# ADDENDUM NO. 2

**July 25, 2022**

**LIBERTY AND WESTCHESTER INTERMEDIATE SCHOOLS -  
ATHLETIC SITE PROJECTS  
Chesterton, IN 46304**

## ADDENDUM TWO

DRAWING  
TELECOMMUNICATION SITE PLAN  
DETAILS

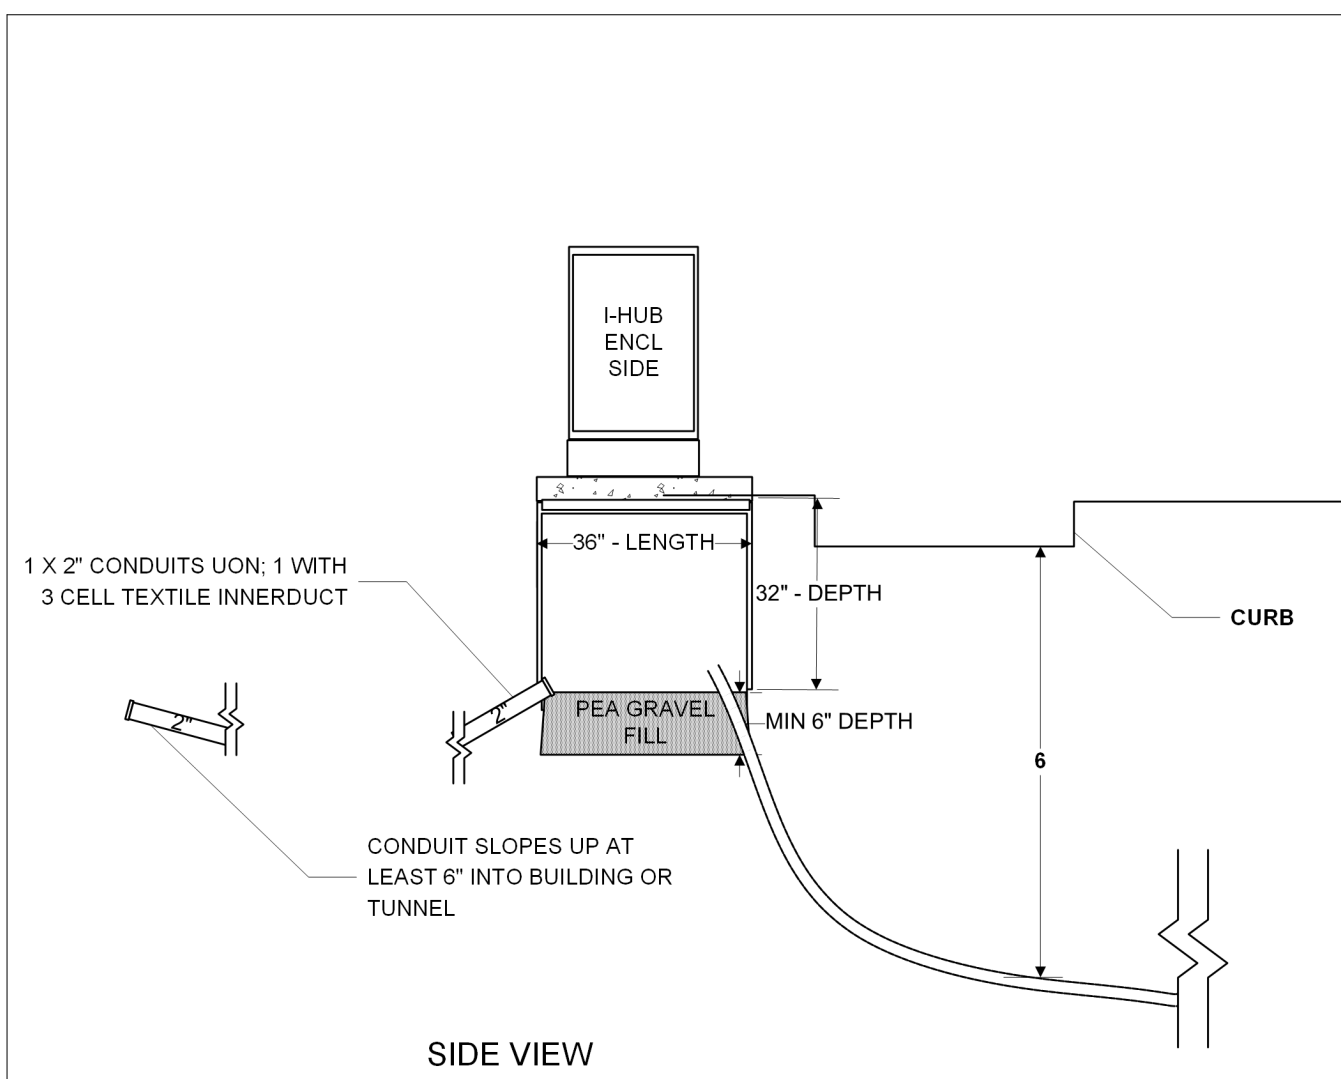
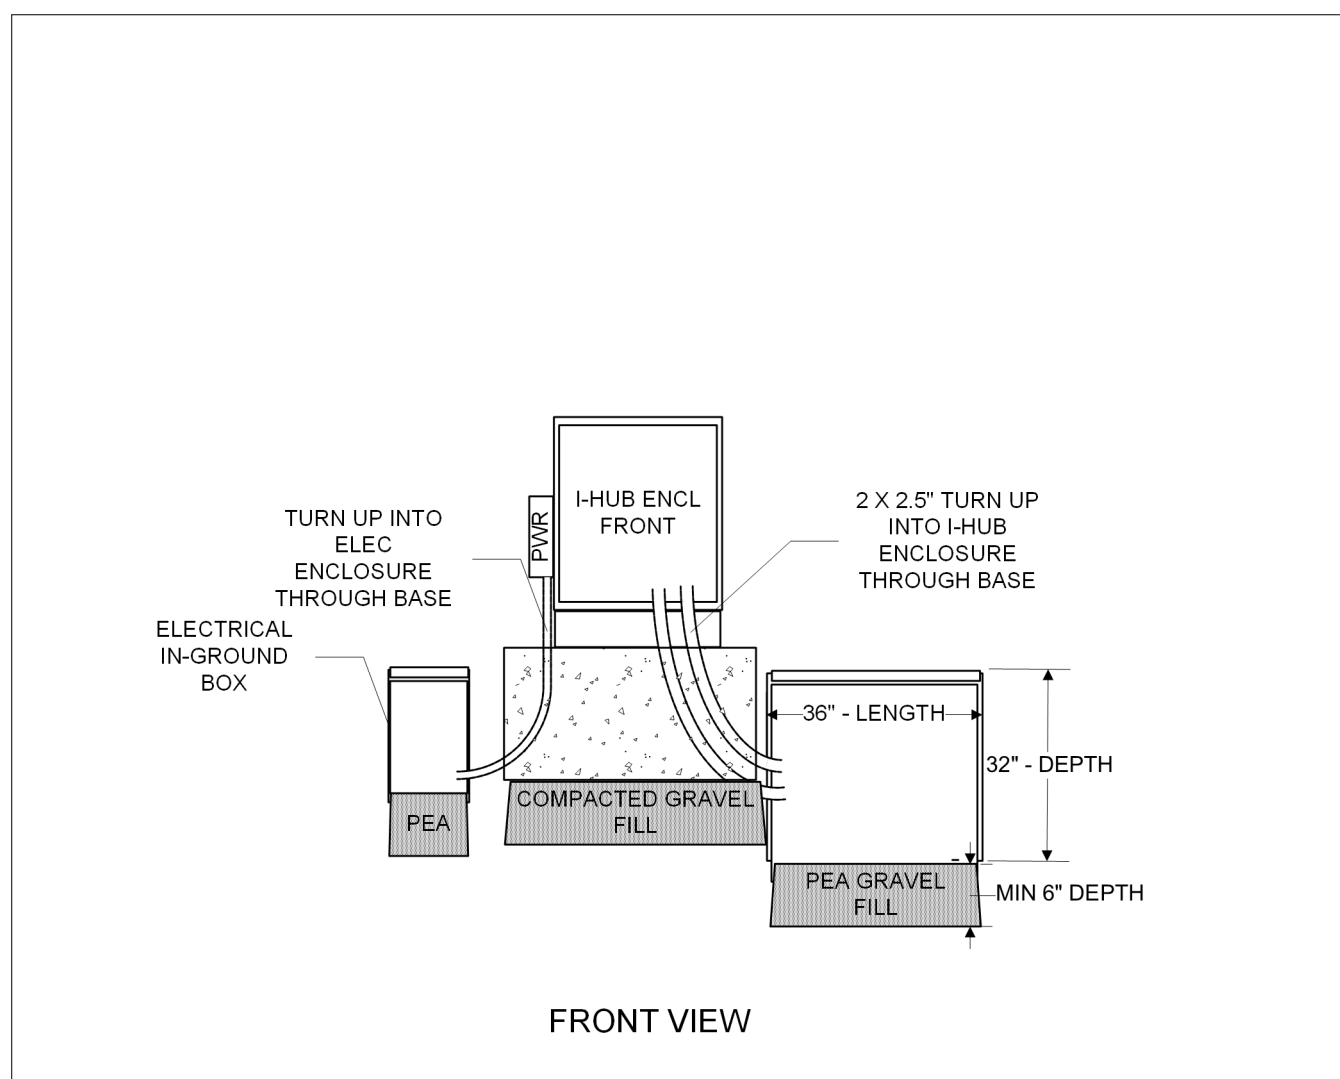
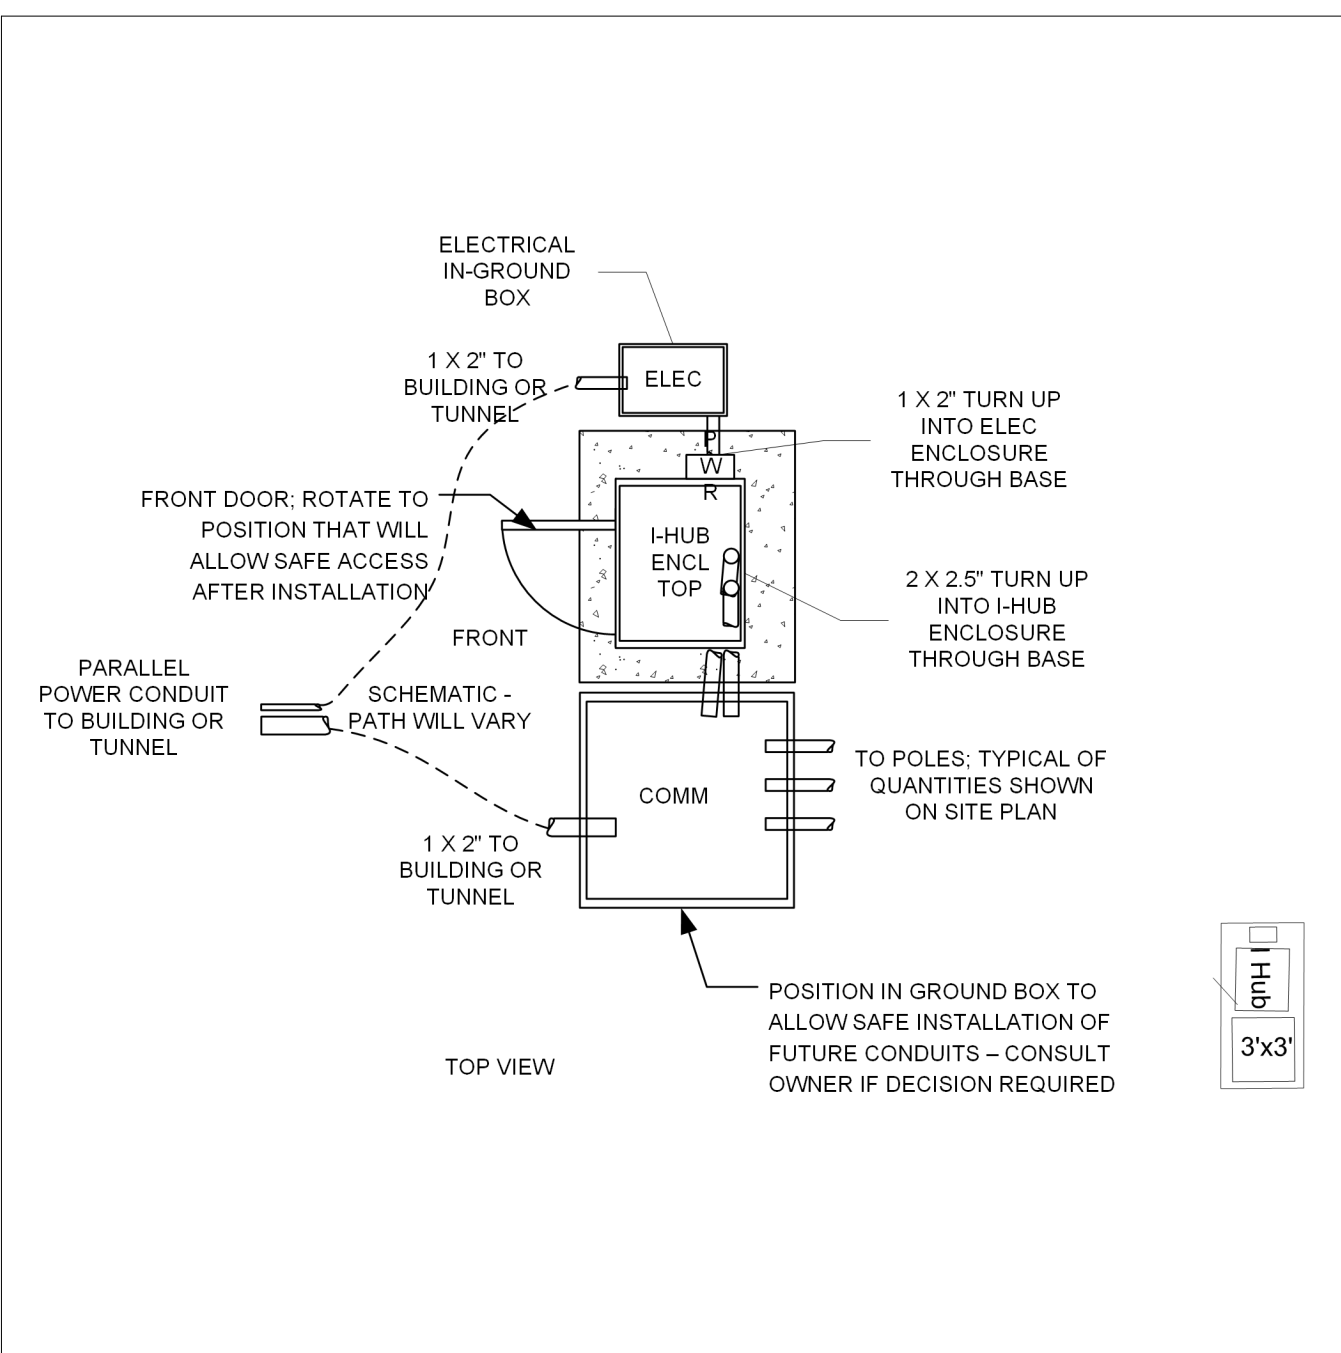
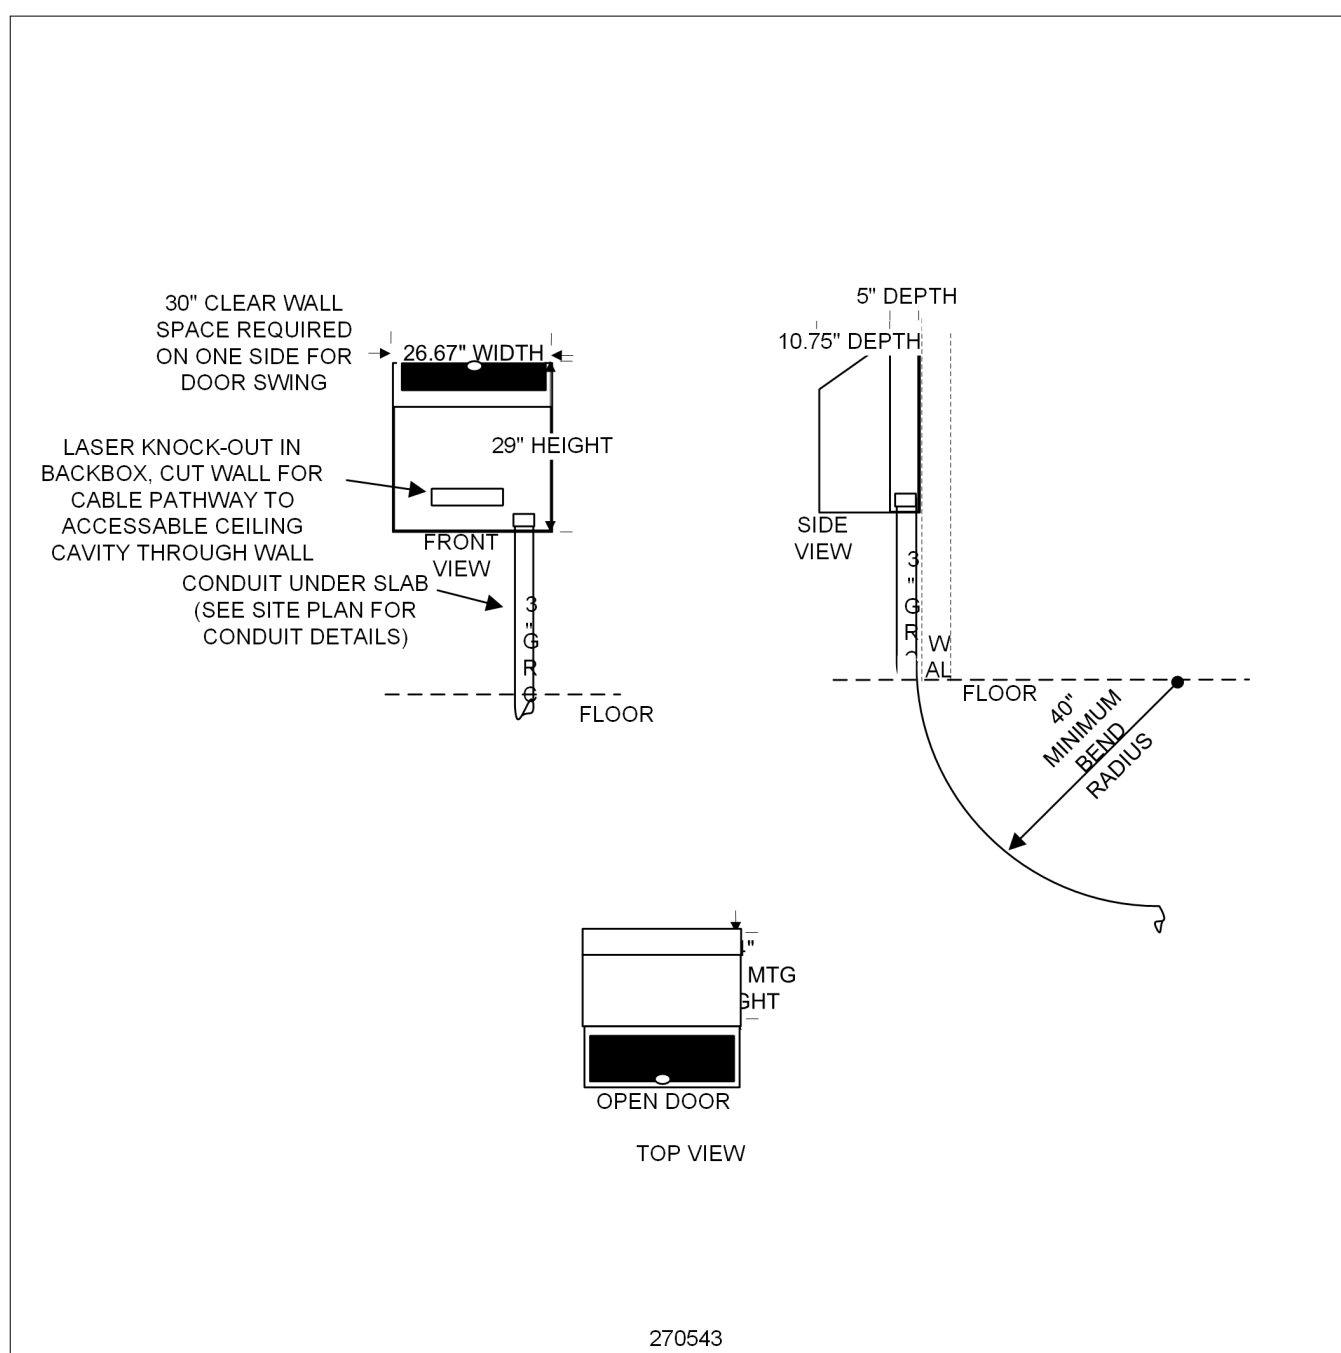
- A. Replace Sheet TS-501 with full-size drawing included in this addendum.
  - 1. Added details for Outdoor Telecom Enclosure that is part of Alternates 13 and 14.
